Planning and Land Use Committee Report

Date: July 7, 2014 **From:** Mike Wilson, Senior Planner - Urban Design
Subject: **Rezoning Application and Official Community Plan Amendment #00427 and Development Permit Application #000340 for 1515 Douglas Street and 750 Pandora Avenue**
Application to increase density to construct two-phase office building with ground floor retail space.

Figure 1: Phasing Diagram

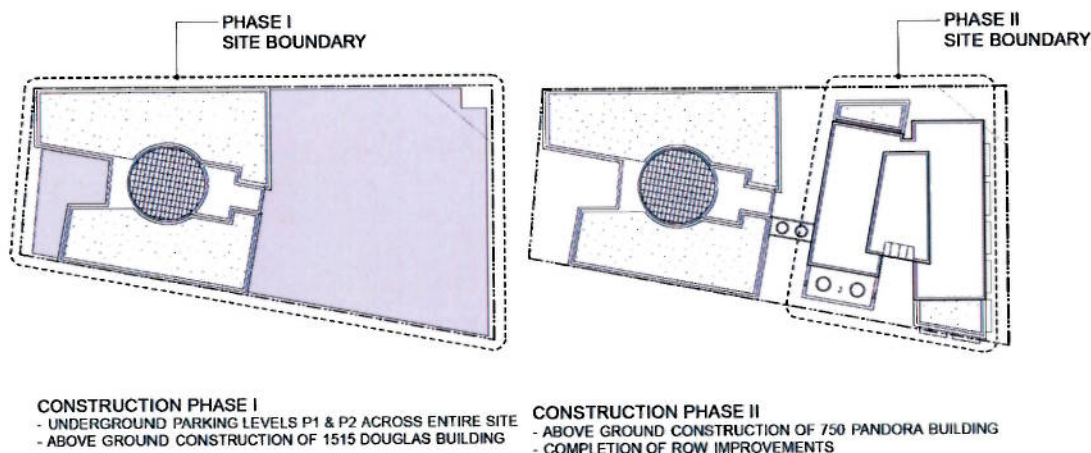
The applicant proposes a *Zoning Regulation Bylaw* amendment to permit the construction of a six-storey retail and office building on the western portion of the site fronting Douglas Street which is to be linked by an enclosed at-grade walkway to a 13-storey retail and office building on the east portion of the site. A total of 220 underground vehicle parking stalls as well as 34 Class 1 and 54 Class 2 bicycle parking stalls are also proposed. The applicant proposes to construct the development in two phases. The first phase would include the construction of the underground parking area in its entirety and the six-storey retail and office building. This building features at-grade retail units, an entry plaza fronting Douglas Street and an internal rotunda space of approximately 240 m². The second phase would include the construction of the 13-storey building and an at-grade mid-block walkway.
